HPC - Connecting Sensors or Flow Meters (Optional)

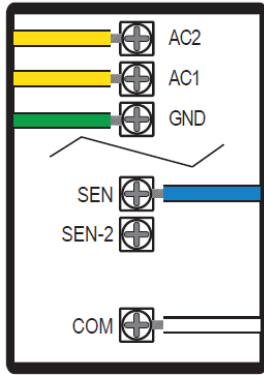
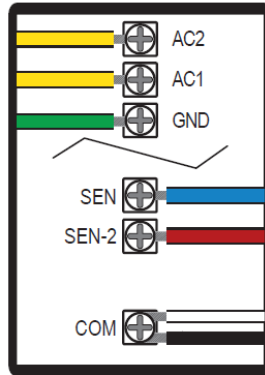
HPC Controllers with date codes of JAN 2023 and newer include two sensor inputs. The SEN-SEN terminals from the original HPC Controllers have been split into SEN and SEN-2 to allow for two separate sensor installations (i.e., flow + rain sensor). Sensors now wire separately across the Common terminal (COM).

Front Panel (Old vs New)	Terminals	Notes
HPC Front Panel (Pre-JAN 2023)	SEN-SEN	Currently, only compatible with a single flow/click sensor. If the front panel (HPC-FP) is upgraded with a 2023 JAN or newer version, there is the option to use the two-sensor configuration.
HPC Front Panel (JAN 2023 or Newer)	SEN and SEN-2	Compatible with two sensors.

1 Sensor

Blue + White to HC Flow Meter

2 Sensors

*Blue + White to HC Flow Meter
Red + Black to Rain-Click*
